**Victorian Planning Authority Projects Standing Advisory
Committee – Referral No. 4
Craigieburn West Precinct Structure Plan**

Advisory Committee Report

17 June 2021

Craigieburn West Precinct Structure Plan

Figure 8 Integrated Water Management Plan

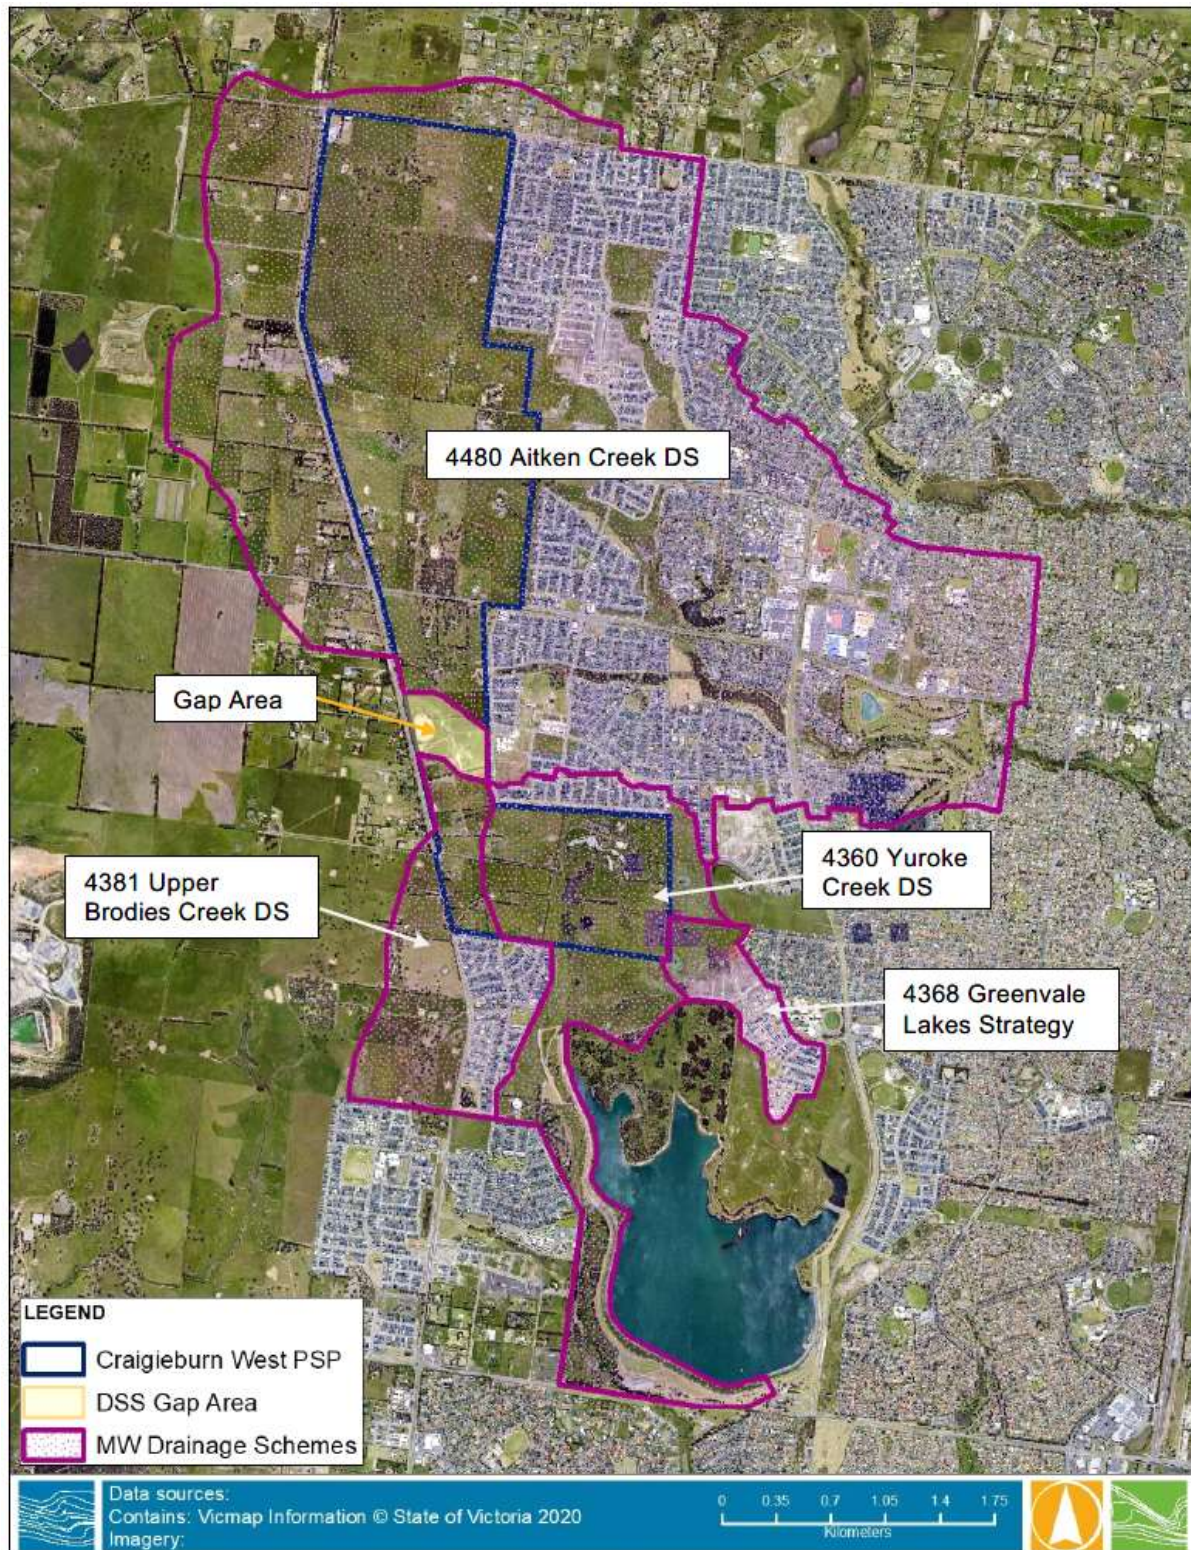
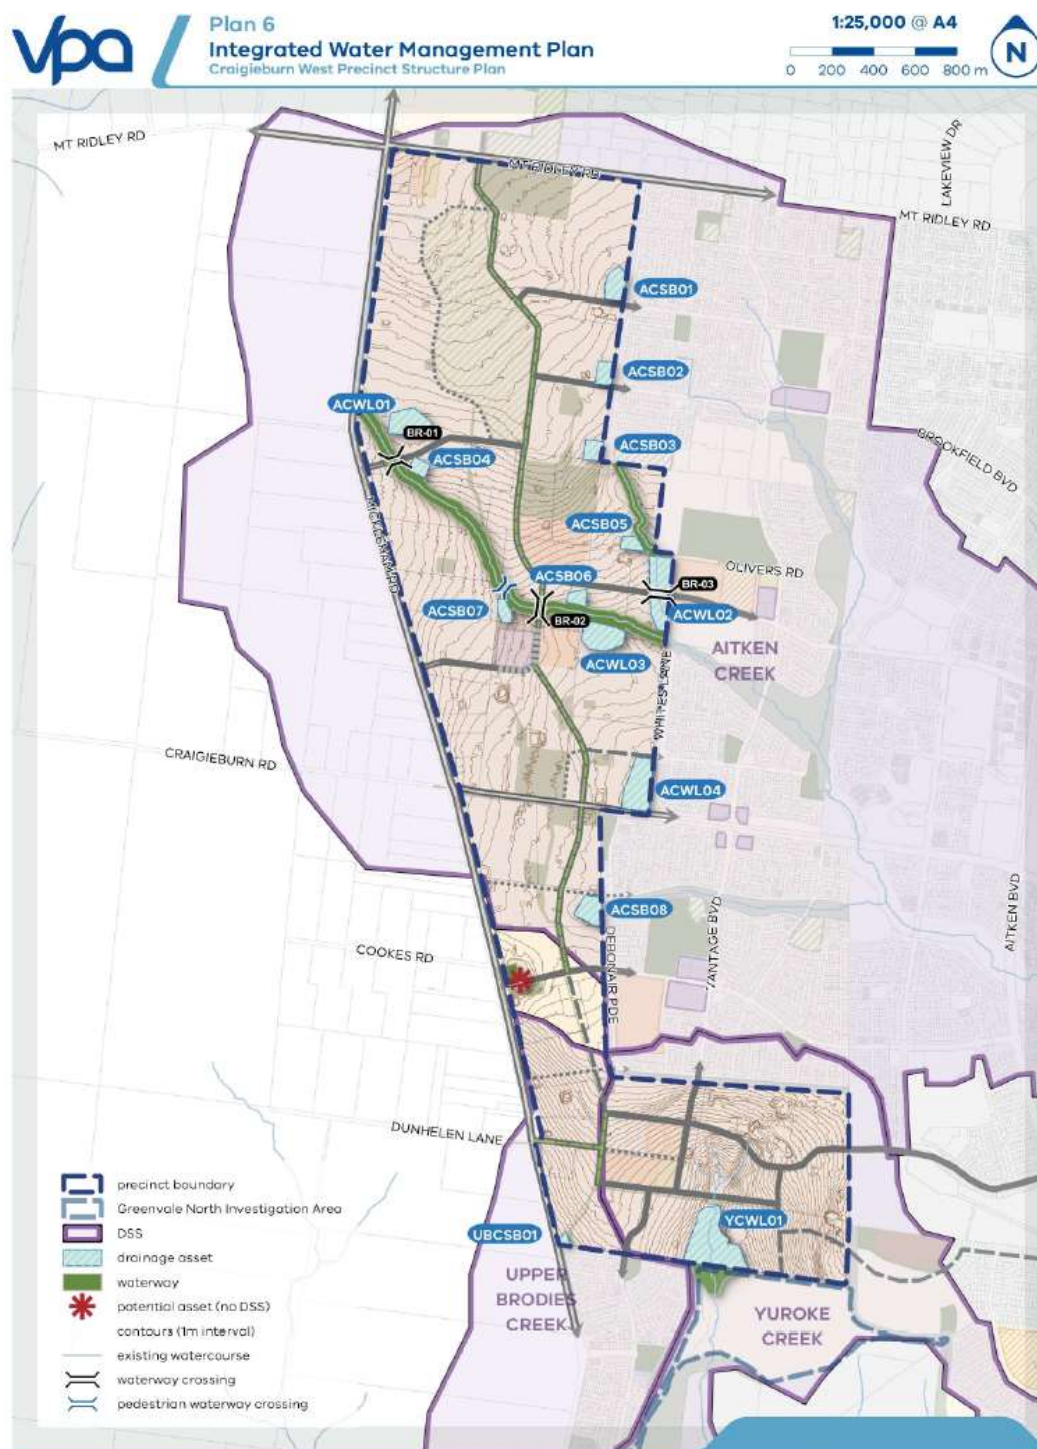
The Gap Catchment is not part of the current DSS areas. It is about 14.5 hectares, and sits between the Aitken Creek and Yuroke Creek DSS areas. The Gap Catchment is located at the western edge of the PSP south of Craigieburn Road.

The location of the PSP and DSSs are shown in Figure 7. The Integrated Water Management Plan is extracted below in Figure 8.

7. **Amend the Integrated Water Management Plan (Plan 6) to show the amended boundaries of the Aitken Creek Drainage Services Scheme and the Yuroke Creek Drainage Services Scheme as outlined in Figure 2 of Mr Mag's evidence (Document 34).** [Chapter 4.6]
8. **Amend the walkable catchment boundaries to extend:** [Chapter 5.3]
 - a) **west of the Local Town Centre to a distance of 90 metres inboard from Mickleham Road**

Figure 15 Proposed northern primary school location

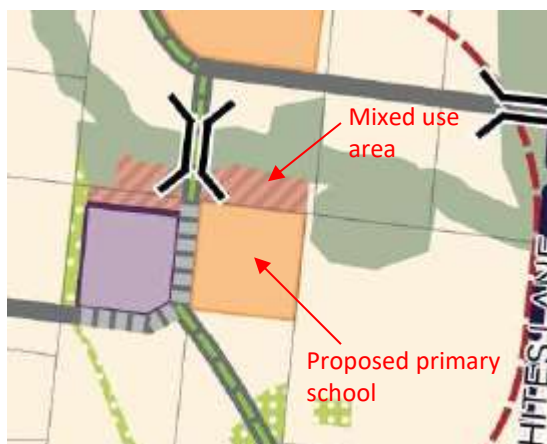
The PSP proposes to locate the northern government primary school next to the LTC, with a strip of mixed use between the school and the Aitken Creek drainage reserve (see Figure 15).

Figure 17 Stockland alternative Place Based Plan based on Conservation Area boundary realignment

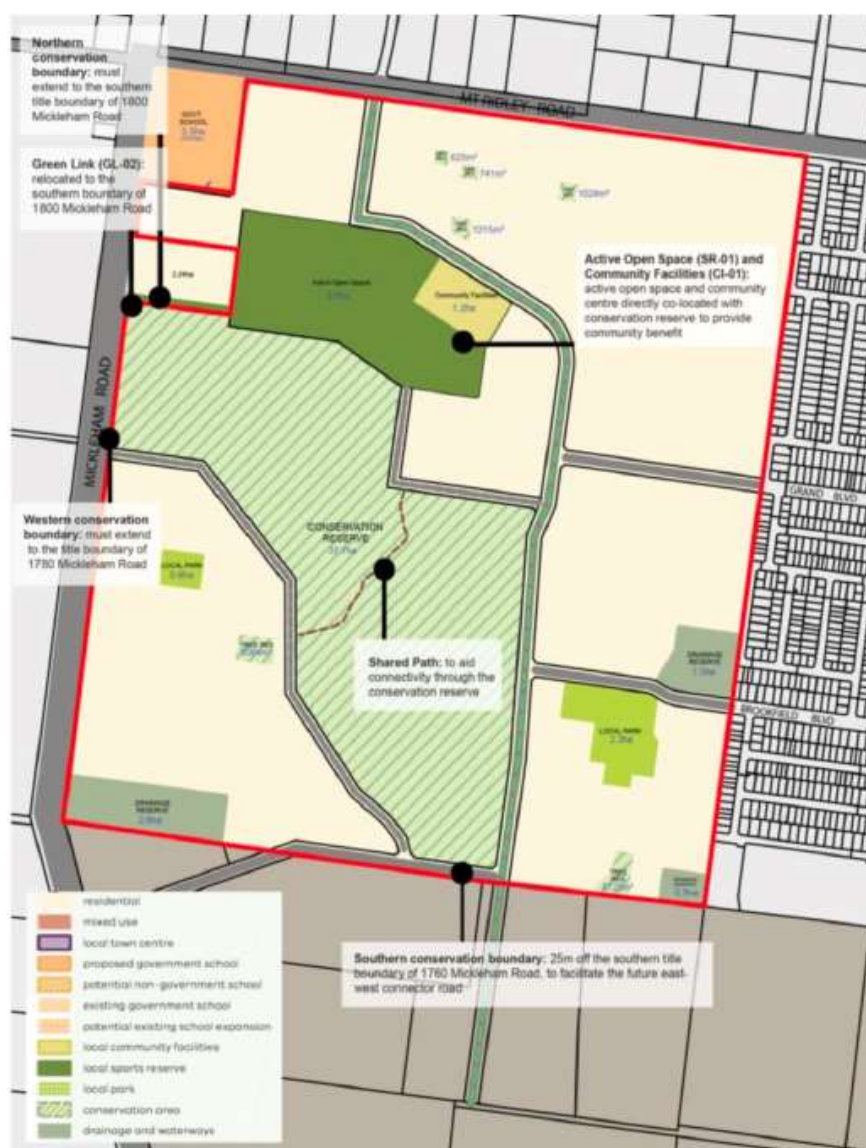
Stockland proposed relocating SR-01 in response to the proposed realignment of the Conservation Area boundaries (see Figure 17 in Chapter 8.3). Stockland called planning evidence from Mr Negri, who noted the co-location of SR-01 with the conservation area and positioned to be accessible to the future residents of the PSP area and neighbouring precincts (Lindum Vale to the north and Craigieburn R2 to the east).

The PSP proposes to show the boundaries of Conservation Area 29 as currently approved (see Figure 3). Agreement has been reached between Stockland, the VPA, Council and DELWP to amend the boundaries as shown in Figure 17 below. Approval has been sought from the Commonwealth Government, but not yet granted.

Figure 18 Bushfire Plan

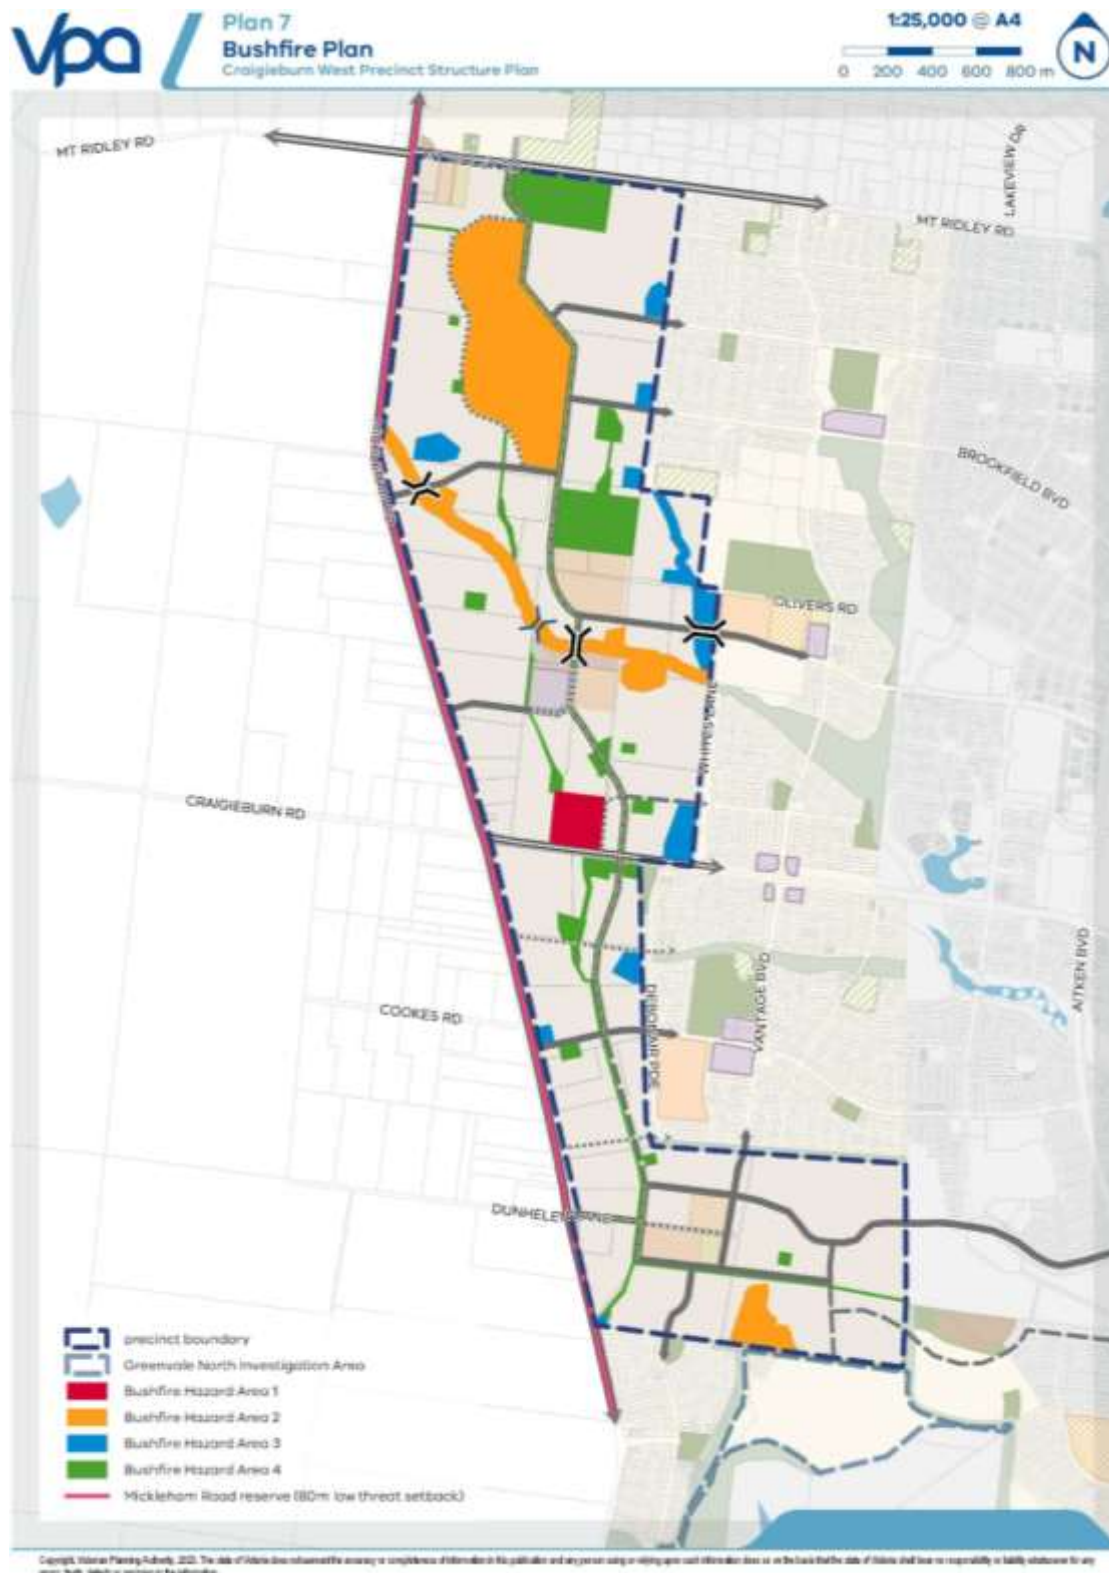
The PSP classifies the areas in the precinct that present a bushfire hazard from Hazard Area 1 (highest) to Hazard Area 4 (lowest). These are shown on the Bushfire Plan (Plan 7), extracted in Figure 18 below.

- Bushfire Hazard Area 1 is applied to areas where the vegetation is classified as Woodland, for example LP-09
- Bushfire Hazard Area 2 is applied to areas where vegetation is classified as Grassland and where the grassland is expected to remain, such as natural waterways
- Bushfire Hazard Area 3 applies to drainage reserves where there is expected to be vegetation but not in a state to pose a hazard
- Bushfire Hazard 4 is similar in that the open space to which it applies will be managed as low threat vegetation by virtue of the intended use of the land.
